Access Compliance Report Public Rights-of-Way (Curb Ramps)

Main Street: **RADIANCE_LN** Cross Street: **MORNING_TRAIL** Location: **SE**

ADA ID: **RPRK211019175904** Ramp Type: **Type 1 - Perpendicular Diagonal Initial Pass/Fail: Fail** Overall Compliance: **No** Severity Score: **2**

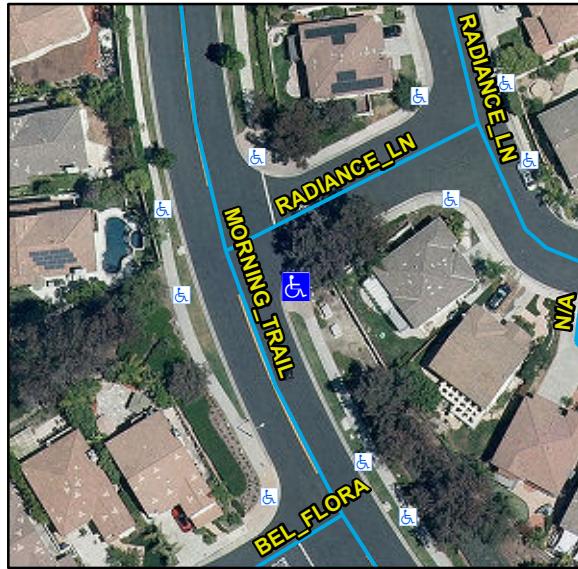
Compliance	Description	Data	Compliance	Description	Data
N/A	Ramp Length (in)	112	N/A	Flare Type LT	
Yes	Ramp Width (in)	48			N/A
Yes	Ramp Run Slope (%)	8	N/A	Flare Slope LT (%)	N/A
No	Ramp Cross Slope (%)	2.7	N/A	Flare Traversable LT	N/A
N/A	Landing Present	N/A	N/A	Flare Type RT	
N/A	Landing Length (in)	N/A			N/A
N/A	Landing Width (in)	N/A	N/A	Flare Slope RT (%)	N/A
N/A	Landing Run Slope (%)	N/A	N/A	Flare Traversable RT	N/A
N/A	Landing Cross Slope (%)	N/A	N/A	DWS Provided	N/A
N/A	Landing Movement Obstructed?	N/A	N/A	DWS Contrast	N/A
	Landing Movement Type	N/A	N/A	DWS Length (in)	N/A
N/A	Landing Shared	N/A	N/A	DWS Full Width	N/A
N/A	Clear Space	Yes	N/A	DWS Offset Left (in)	N/A
N/A	Clear Space To Crosswalk (in)	N/A	N/A	DWS Offset Right (in)	N/A
N/A	Marked Crosswalk 1	No	N/A	Marked Crosswalk 2	No
	Crossing 1 Direction	N		Crossing 2 Direction	W
	Marked Crosswalk 1 Width (in)	N/A		Marked Crosswalk 2 Width (in)	N/A

N/A	Ramp Inside Crosswalk 1	N/A	Yes	Ramp Inside Crosswalk 2	N/A
	Crossing 1 Slope (%)	3.9		Crossing 2 Slope (%)	0.2
	Crossing 1 Cross Slope (%)	8		Crossing 2 Cross Slope (%)	4
N/A	Gutter Ponding	N/A	No	Curb Slope	5.8
Yes	Gutter Lip Height (in)	0		Road Run Slope (%)	4.4
N/A	Gutter Run Slope (%)	N/A		Road Cross Slope (%)	1.2
N/A	Gutter Cross Slope (%)	N/A			
Yes	Overall Surface Condition: Acceptable		Yes	Perp Joint Present	Yes
	Cross Gutter Present?	No		Spandrel Present?	No
	Replace Cross Gutter?	N/A		Replace Spandrel?	N/A

Remove & Replace Curb Ramp With Two New Directional Ramps or Equivalent.

R304.2.2, R304.5.3, STD 1115
